CITY PLAN COMMISSION**THURSDAY, NOVEMBER 3, 2022****FILE NUMBER:** S223-004**SENIOR PLANNER:** Mohammad H. Bordbar**LOCATION:** Creek Drive at Oxford Drive, north corner**DATE FILED:** October 5, 2022**ZONING:** PD 765**PD LINK:** <https://dallascityhall.com/departments/city-attorney/Articles/PDF/Article%20765.pdf>**CITY COUNCIL DISTRICT:** 12 **SIZE OF REQUEST:** 7.828-acres **MAPSCO:** 5C**APPLICANT/OWNER:** Plano Independent School District

REQUEST: An application to replat a 7.828-acre tract of land containing all of Lots 6 through 10 in City Block 1/8728, all of Lots 12 through 18 in City Block J/8728 and part of Lot 1A in City Block J/8728 to create one lot on property located on Creek Drive at Oxford Drive, north corner.

SCALE 1" = 50'
DATE: SEPTEMBER 28, 2022
ACR No. 2022-205 P.A.

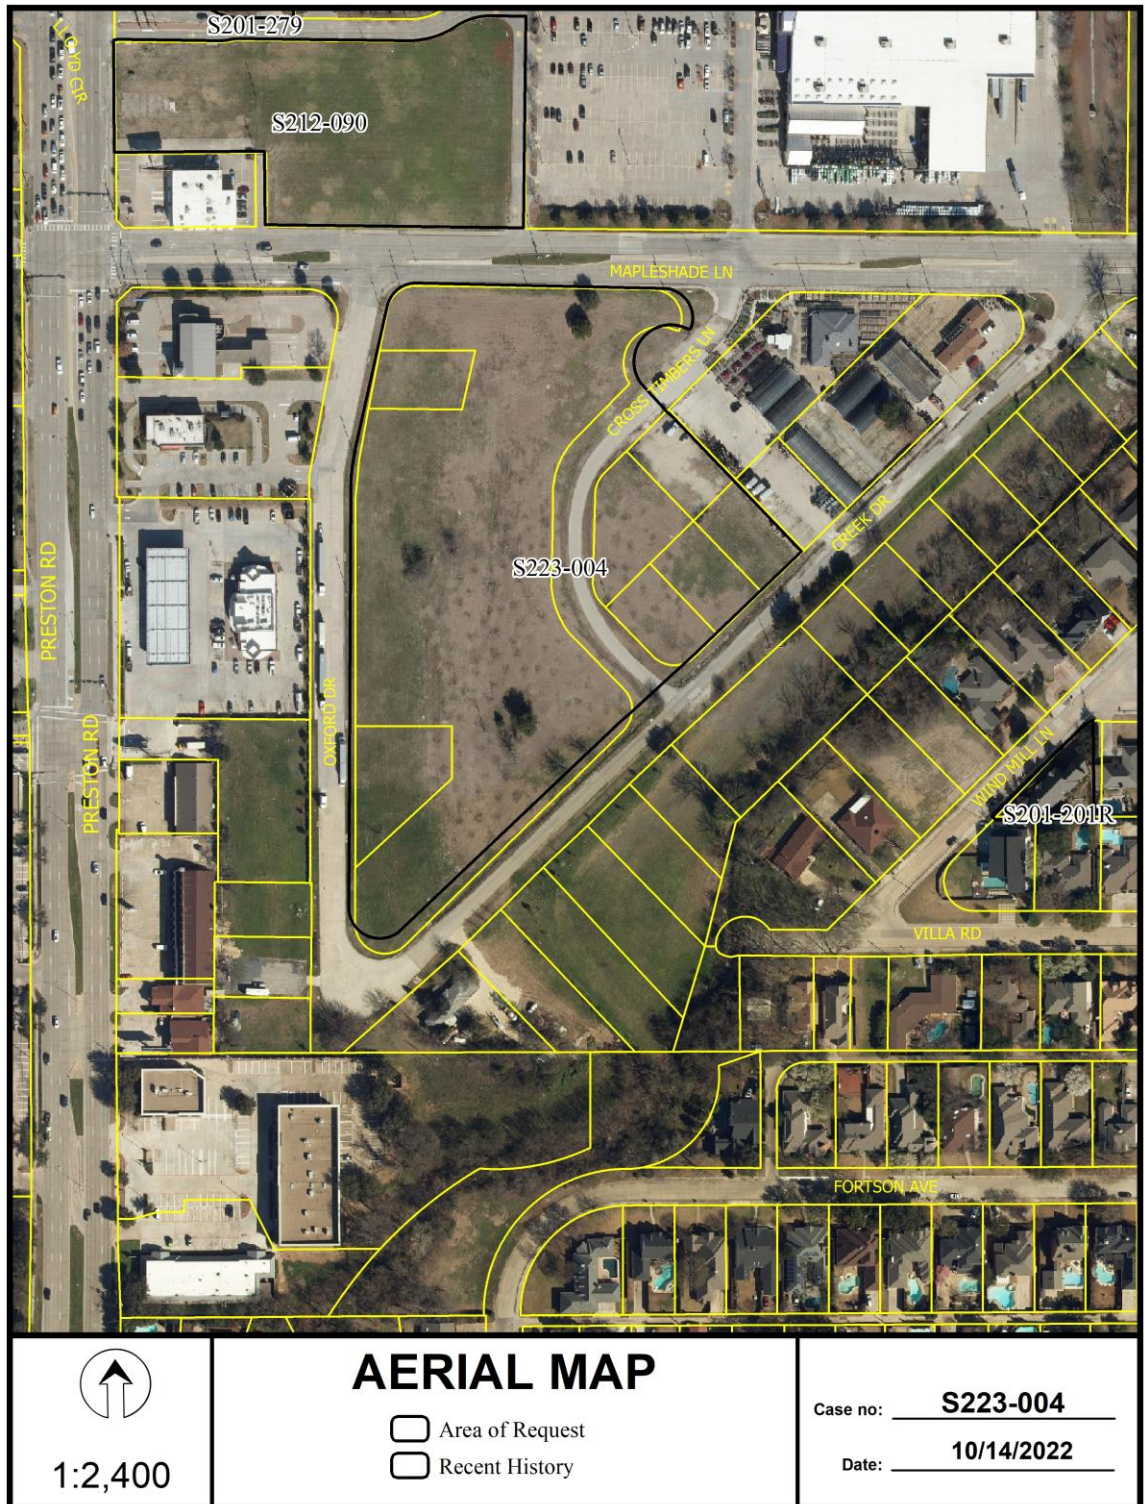
31. On the final plat, use standard language for 10'Easement abandonment noted on the plat as follows: "Abandonment authorized by Ordinance No._____, recorded as Inst. No._____. Contact Real Estate and advise if the language noted on the

plat 10' Sidewalk Easement, 20' Wastewater Easement and Water Easement by this plat is a dedication or an abandonment.

32. On the final plat, change "Mapleshade Lane" to "Mapleshade lane (F.K.A. Brandywine Lane)". Section 51A-8.403(a)(1)(A)(xii)
33. On the final plat, identify the property as Lot 1B in City Block J/8728. Ordinance 1A, Page 131 pages 131-148, Section 2 (passed August 13, 1872).
